UNITED STATES  
NUCLEAR REGULATORY COMMISSION  
WASHINGTON, D. C. 20555

Generic Task No. A-39

SUBJECT: SUMMARY OF MEETING HELD ON APRIL 4, 1979 WITH REPRESENTATIVES  
OF THE GENERAL ELECTRIC COMPANY TO DISCUSS SRV METHODOLOGY

MULTIPLE  
QUENCHER  
METHODS  
NRC QUESTIONS

Figure 14 . Effect of Pipe Air Volume on Frequency for Initial Pipe and Wetwell Pressure of 3.7 psia

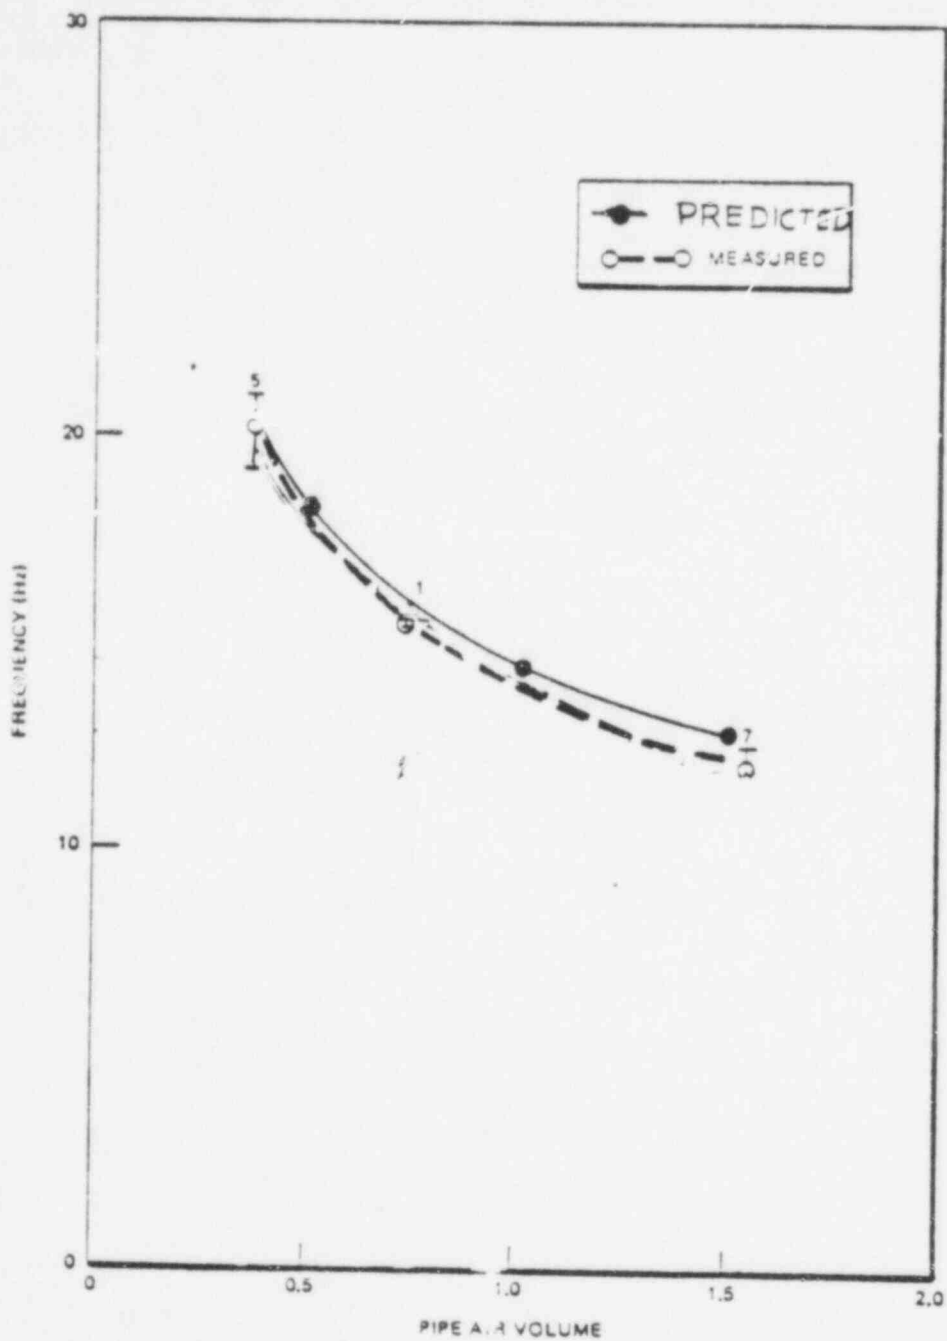
QUESTION 9: IT IS PROPOSED THAT THE QBF DISTRIBUTION BE SHIFTED TO ACCOUNT FOR SRV LINE VOLUMES THAT DIFFER FROM THE 50 FT<sup>3</sup> LINES USED TO OBTAIN THE DATA. THE PROPOSED ADJUSTMENT IS BASED ON A SIMPLISTIC AND POSSIBLY NON-CONSERVATIVE ANALYSIS WHICH NEGLECTS THE KNOWN DEPENDENCE OF BUBBLE PRESSURE ON AIR LINE VOLUME. A REASSESSMENT OF THIS ASSUMPTION IS REQUIRED.

THE RELATIONSHIP GOVERNING FREQUENCY AND AIR VOLUME IS, FROM RAYLEIGH'S EQUATION

$$\text{FREQUENCY} \propto \sqrt[3]{\text{AIR VOLUME}}$$

THE ENTIRE RELATIONSHIP HAS BEEN EXPERIMENTALLY CONFIRMED IN 1/4-SCALE T-QUENCHER TESTS FOR LINE VOLUMES RANGING FROM 24 FT<sup>3</sup> TO 99 FT<sup>3</sup> (SEE FIGURE 14)
